## ADDENDUM No. 3

### RFP No. 22-76

#### East Medical Center Drive Bridge Rehabilitation and Widening Project

PROJECT MANAGEMENT - PUBLIC SERVICES - CITY OF ANN ARBOR	
<b>EAST MEDICAL CENTER DRIVE</b>	
<b>SUPERSTRUCTURE DETAIL</b>	
SCALE HOR. 1/16"=1'-0"	INCH 0 1
DRAWING NO. <b>2021-008-BR47</b>	
SHEET NO. 110 OF 153

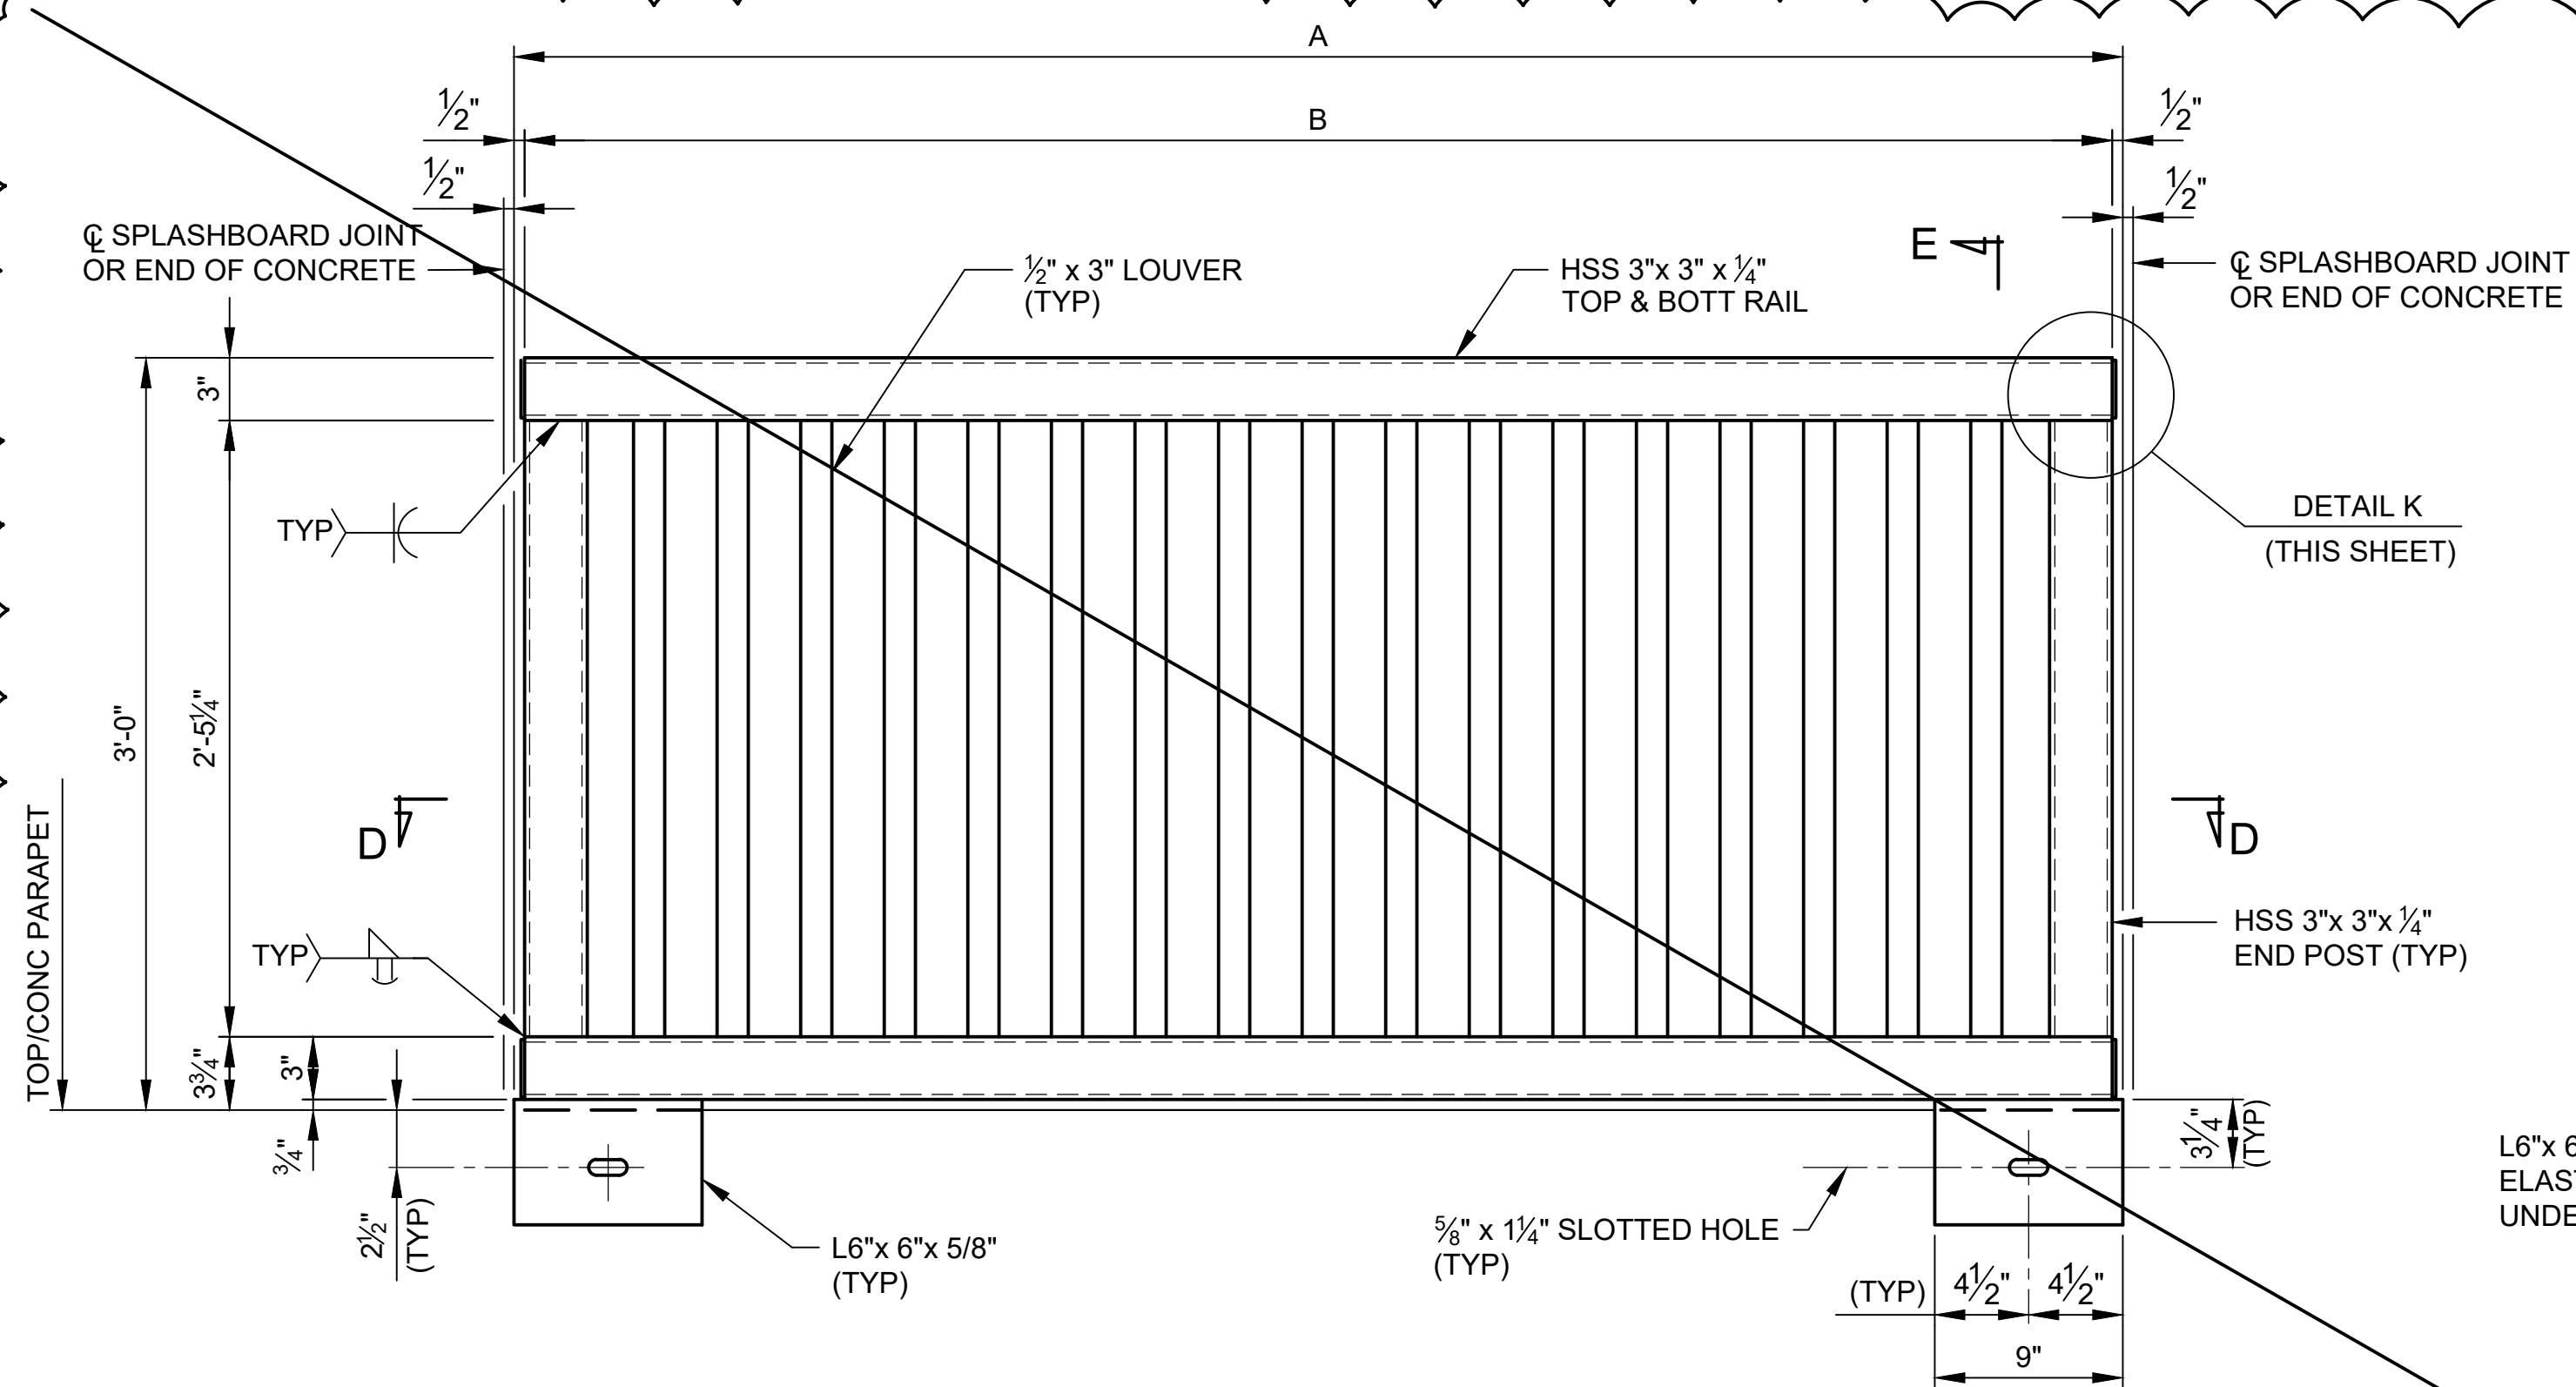
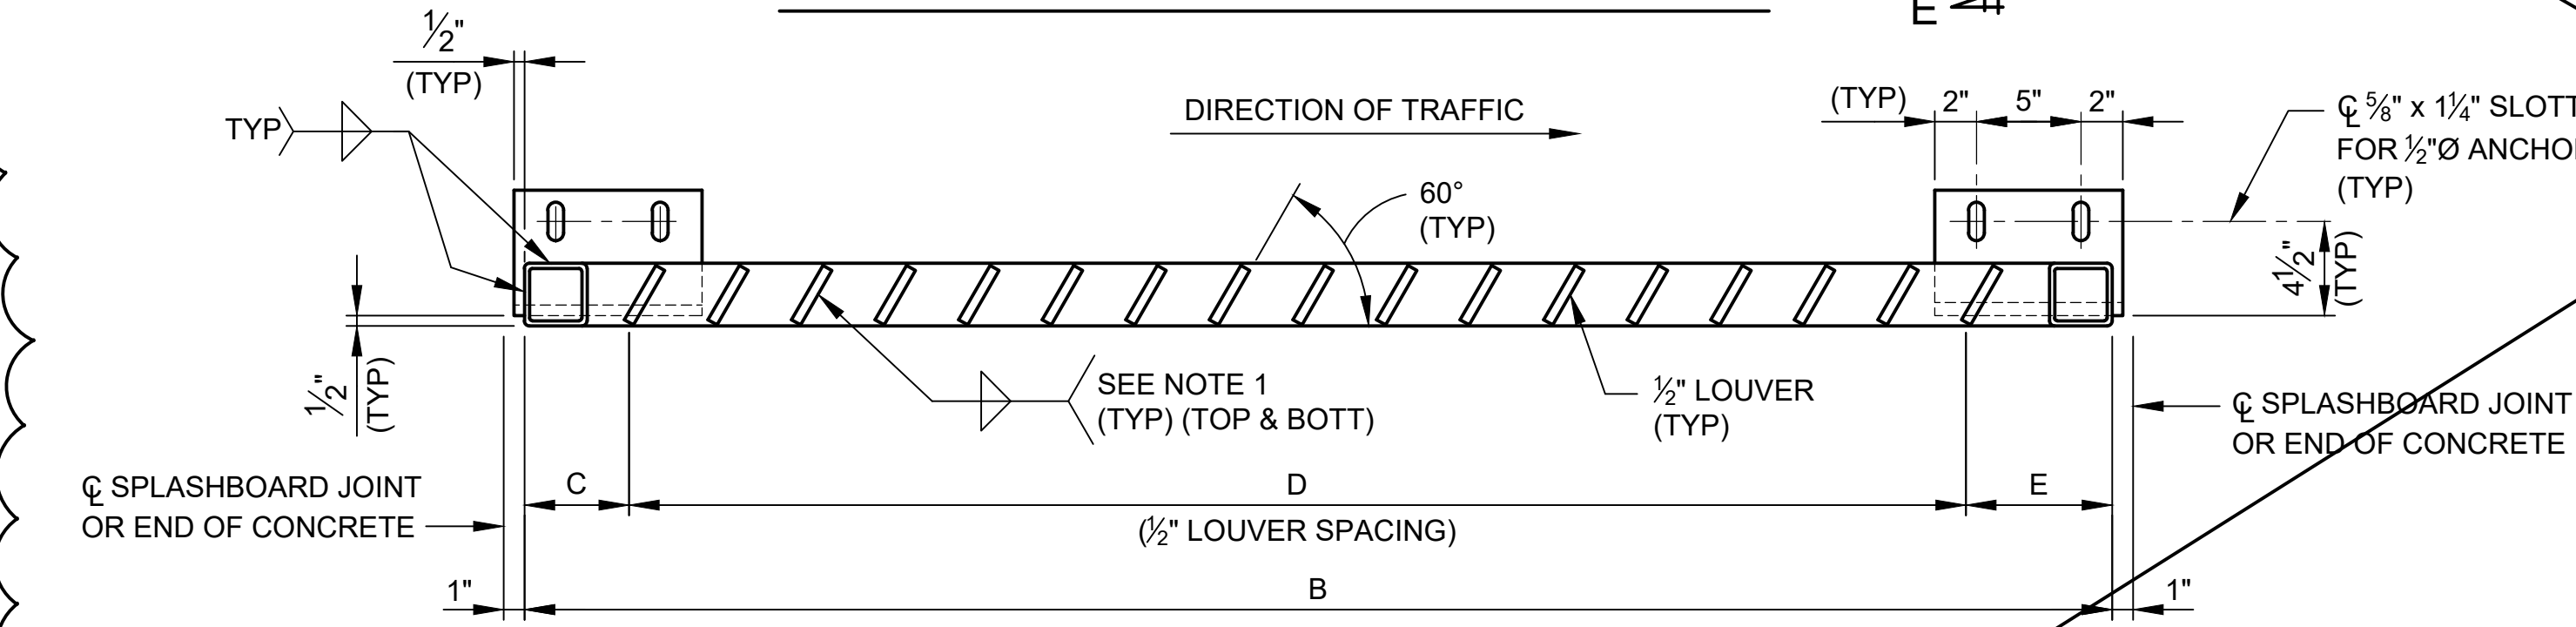
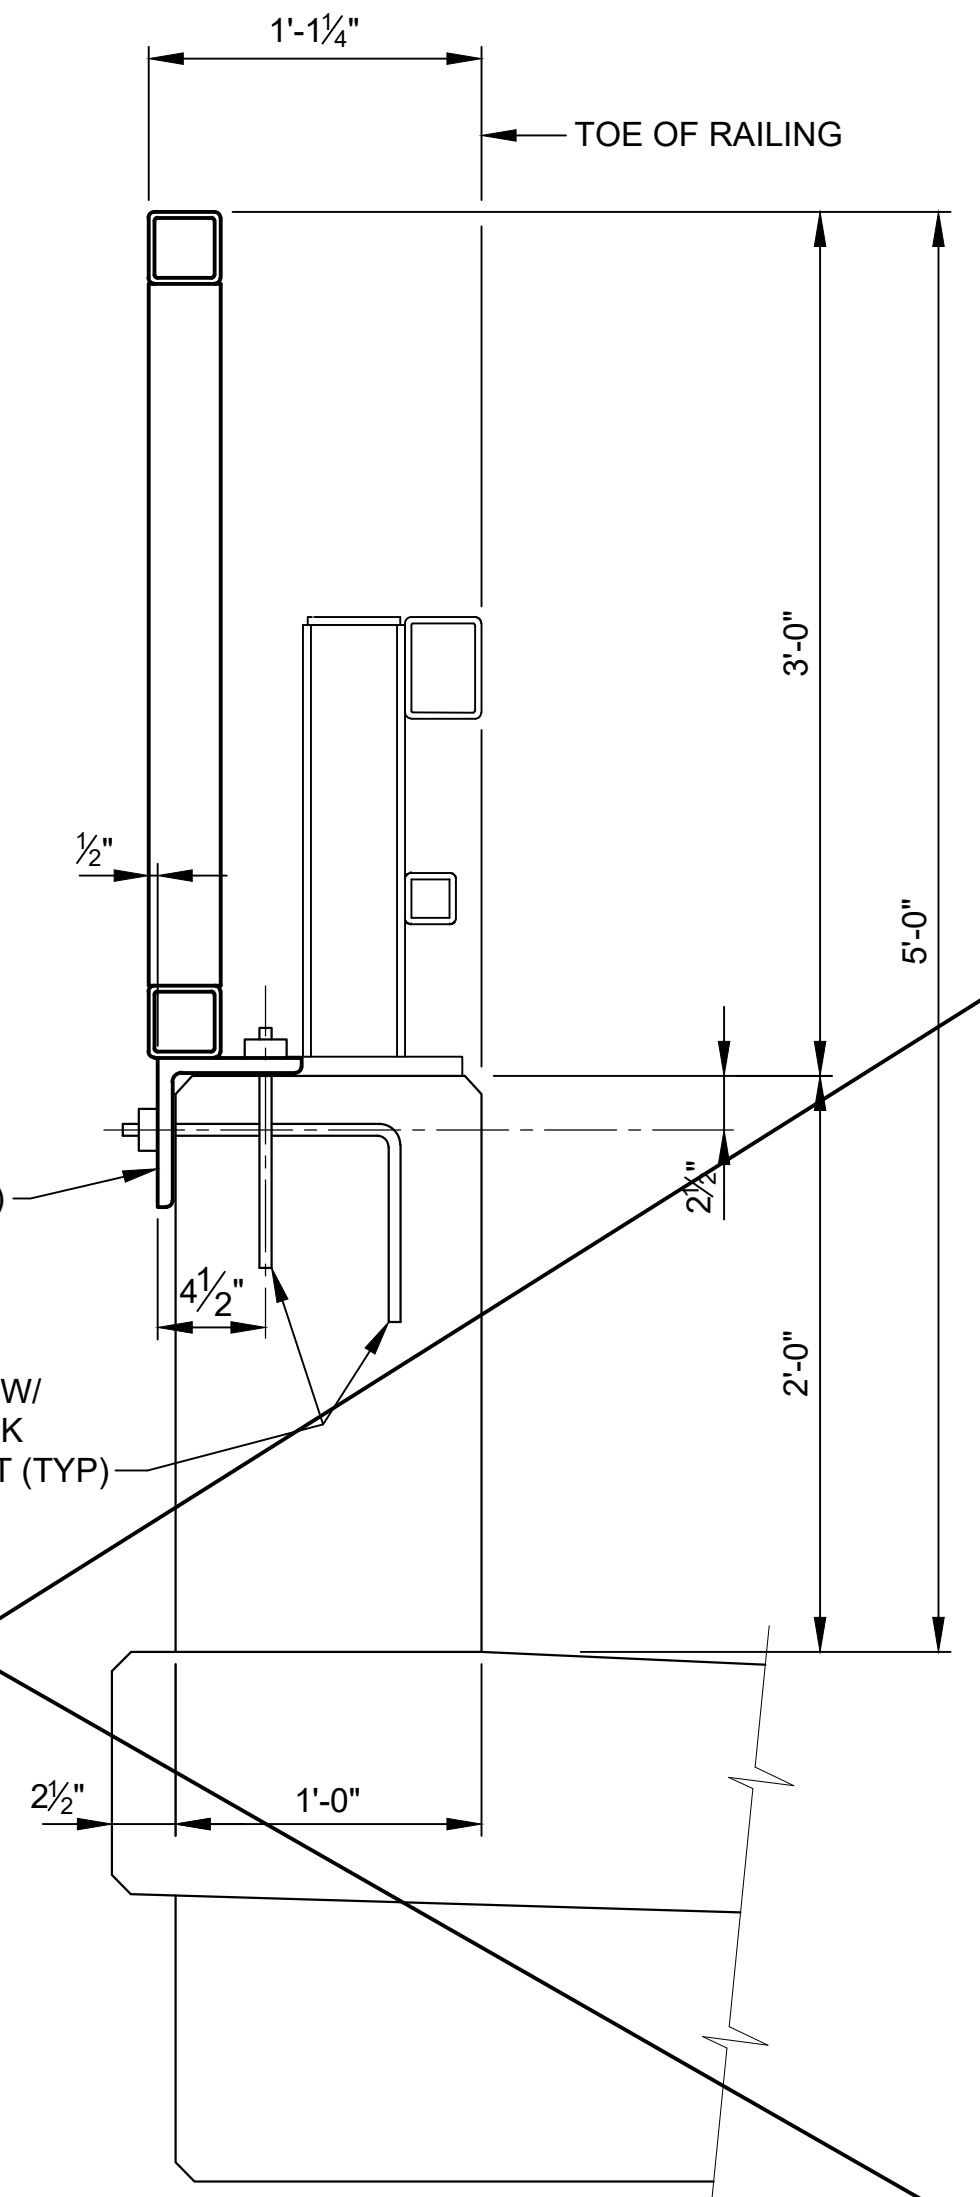
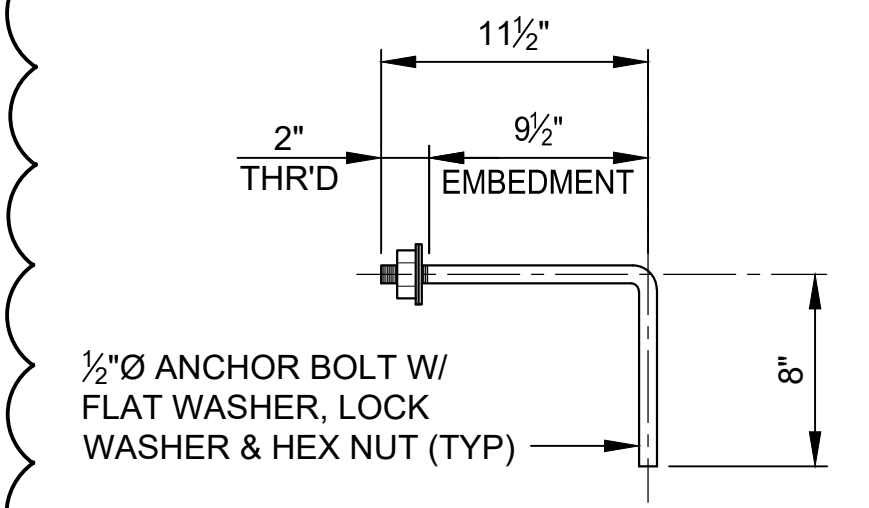
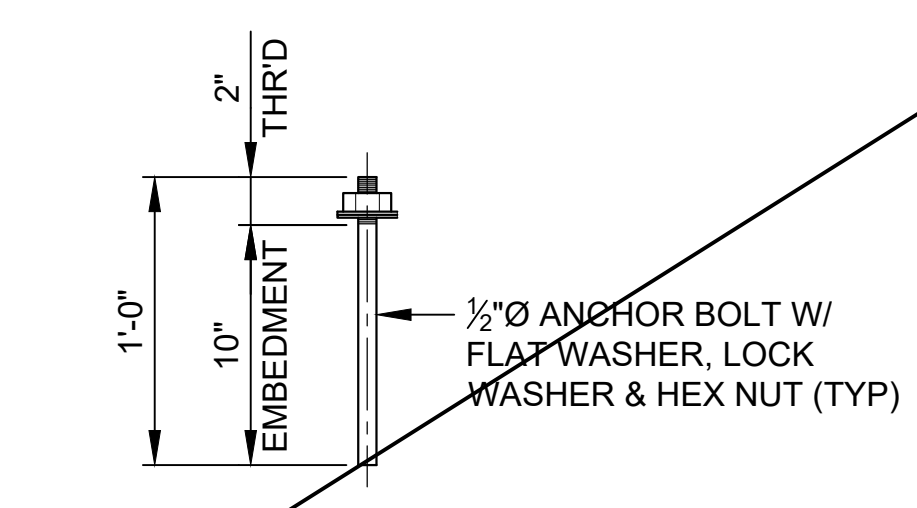
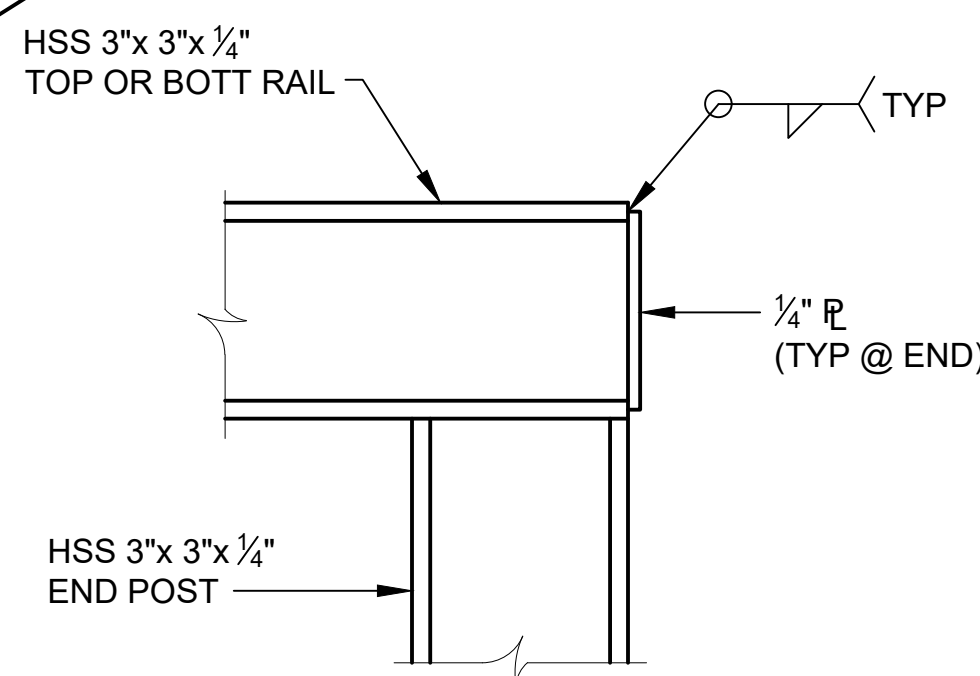
Section/Page(s)	Change
RFP_22-76_Plans Sheet 2	Sheet 110 has been deleted from the set. Sheet 134A (MDOT Standard Plan B-41-C) has been added to the set.
RFP_22-76_Plans Sheet 3	A railroad note has been added to the plans stating that "all work must be completed in accordance with Amtrak EP3006 "Designated Construction Criteria for Overhead Bridges"."
RFP_22-76_Plans Sheet 4	Pay items No. 7070050 "Structural Steel, Mixed, Erect" and 7070051 "Structural Steel, Mixed, Furn and Fab" were decreased from 51,984 lb to 38,695 lb (CATG 0001) and 66,146 lb to 52,857 lb (Total).  Pay item No. 7130010 "Beam Plate, Seal Perimeter" was increased from 1,660 ft to 2,320 ft.

\*\* SHEET NO. 110 OF 153 SHOWING THE SPLASHBOARD DETAILS HAS BEEN DELETED FROM THE SET.  
\*\*\* SHEET NO. 134A OF 153 SHOWING MDOT STANDARD PLAN B-41-C FENCING FOR BRIDGE RAILING, AESTHETIC PARAPET TUBE HAS BEEN ADDED TO THE SET.
